Docket Item #8
BAR CASE# 2005-0055

BAR Meeting
March 23, 2005

ISSUE: Addition and alterations

LOCATION: 421 North Fayette Street

Figure 1 - Roof plan showing new construction

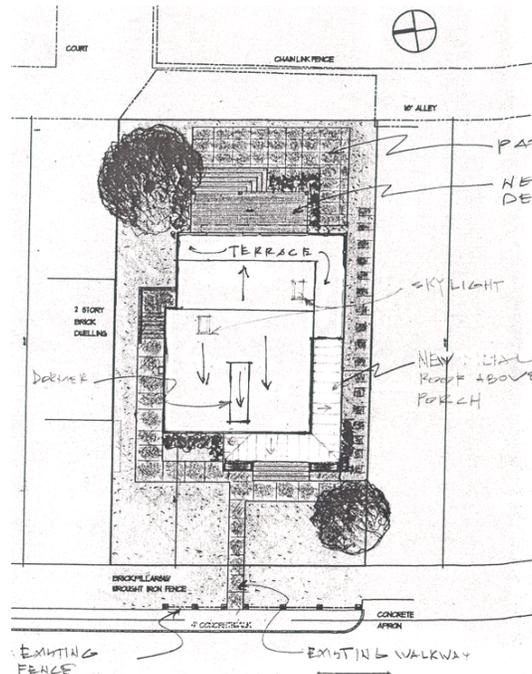
In particular, Staff objects to the extension of the gable roof to create a third story at the rear. The resulting asymmetrical roofline is peculiar and the mass at the rear of the house overwhelming. Staff notes that the original plans incorporated a two bedroom basement apartment. As a basement apartment is not allowed under zoning, it has been eliminated from the plans, but the space remains, now allocated to storage, workshop and recreation room. Staff wonders if the uses housed in the third story extension could not be accommodated elsewhere, such as in the basement. If the attic story must be used for living purposes, Staff recommends exploring an option with a more conventional and less overwhelming appearance, such as raising the roof equally on both sides to create a steeper gable with a more harmonious appearance and utilizing dormers to add light and headroom.

- The skylight should be eliminated from the front slope of the roof. According to the *Design Guidelines*, skylights should not be located on the portion of the roof facing the street (Skylights - Page 1).
- The corner windows on the front (west) elevation of the addition should be moved to be centered in the wall. Staff does not object to the use of corner and strip windows in the rear, but believes that at least on the front, the addition should utilize a more traditional vocabulary.
- The full length paired windows proposed for the west end of the south elevation on the first story appear to be left over from a previous iteration of the plans and do not relate to any window type elsewhere on the plans. Staff recommends that the existing single window be retained or that the pair be composed of windows of the same type and size found on the existing house.

Figure 3 North elevation

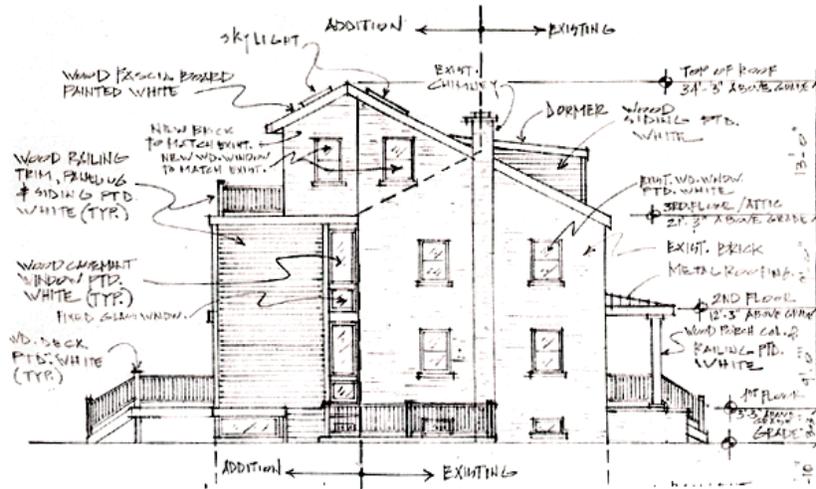
The north elevation of the existing house will remain as is on the first and second stories. The extended roof slope will create a new third story to the east of the centerline. The wall of this new section will be clad in brick to match the existing and will have a wood window matching the existing. Exterior access to the basement will be moved from the rear of the building to the north side. An areaway will be created at the eastern end of the north elevation and will be surrounded by a wood railing. An existing basement window will be converted to a door.

The addition will be set back from the north wall by 2'. The addition will be clad in wood siding on the first and second stories and brick on the third story. The third story will not be as deep as the first and second stories. The top of the second story will be flat, and will be surrounded by a wood railing to serve as a deck for the third story. The third story will be capped with the short slope of the asymmetrical gable roof. There will be a window in the basement level. The first and second stories will be lit by fixed windows located in a strip at the west end of the wall abutting the rear wall of the existing house. These windows will be vertically aligned and will appear as strip, linked by wood panels below the windows and a two story trim board.

Figure 4 Rear elevation

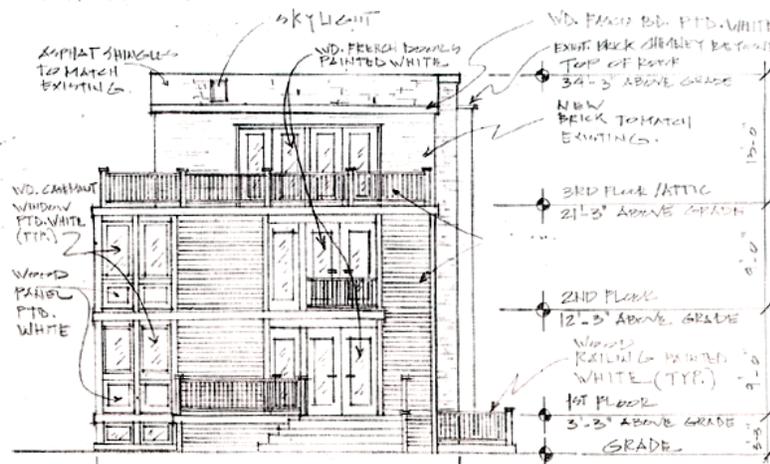
The proposed new construction will obscure all of the existing house at the rear except for a 2' wide section at the north corner. As mentioned above, the addition is offset from the north face of the house by 2' and it extends beyond the south face by 5'6". The addition will be clad in wood siding on the first and second stories and with brick on the third story. The third story will not be as wide or as deep as the addition below. The top of the second story will be flat, and will be surrounded by a wood railing to serve as a deck for the third story. The third story will be capped with the short slope of the asymmetrical gable roof. The roof will be clad in asphalt shingles to match the existing.

A wood deck with wood railings will extend out from the addition on the first story. The deck will be 3'3" above grade, 21'8 1/2" wide and 8' deep. It will be accessed by a set of broad steps located on the north end. The material of the steps is not indicated on the plans. There will be two windows at the south corner of the addition at basement level. The first and second stories of the addition are treated identically: there will be paired wood casement windows with wood panels below at the south corner and a set of wood fully glazed french doors with a fully glazed sidelight located to the north. The windows and doors in the first and second stories will be aligned vertically. The third story will have two sets of wood fully glazed french doors in the center of the east elevation. There will be a skylight located toward the south end of the roof.

Figure 5 South elevation

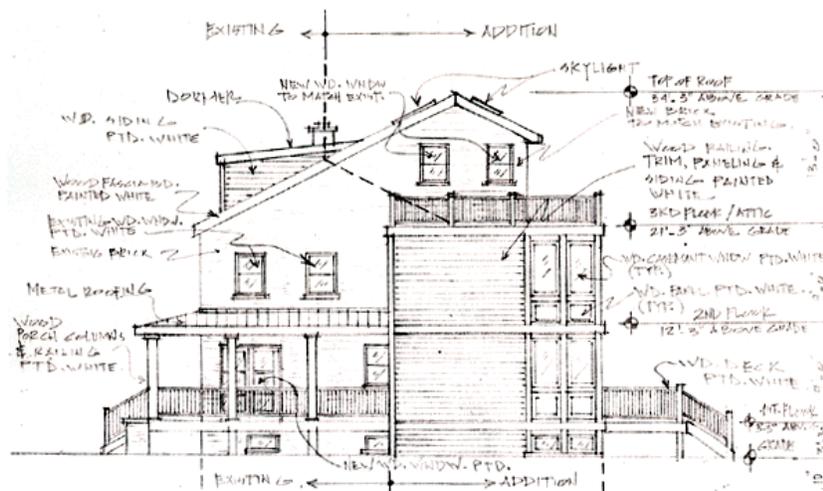
The existing house will have a number of alterations on the south elevation. A pair of new full height windows will replace a single window on the west end of the south elevation on the first story. These windows will be wood, but the configuration and type is unclear. As on the front, the porch will be supported by wood columns with a wood railing and metal clad hip roof. Unlike the front which has a solid brick foundation, the porch will have brick piers on the side.

The new third story extension of the existing house will have two wood windows matching the existing. The two story frame addition will be clad in wood siding and will be identical on the first and second stories. There will be paired wood casement windows with wood panels below at the west corner. There will also be paired windows in the basement level. There will be a deck on the top of the second story which will be surrounded by a wood railing.

- The proposed windows on the south elevation of the addition are located at 5' from of the interior lot line. All exterior walls within 5' from an interior property line must have a fire resistance rating of 1 hour from both sides with no openings permitted or a 2 hour fire wall may be provided. Staff recommends that the south wall of the addition be moved back several more inches from the property line to ensure that it meets the code setback requirement when built.
- Alterations may be required to meet emergency escape requirements of the USBC for the basement.
- The submitted plans appear to exceed height and area requirements of the USBC and may require a sprinkler system. Staff notes that sprinkler systems can add substantially to the cost of a project and have caused applicants to reconsider their plans in previous cases.
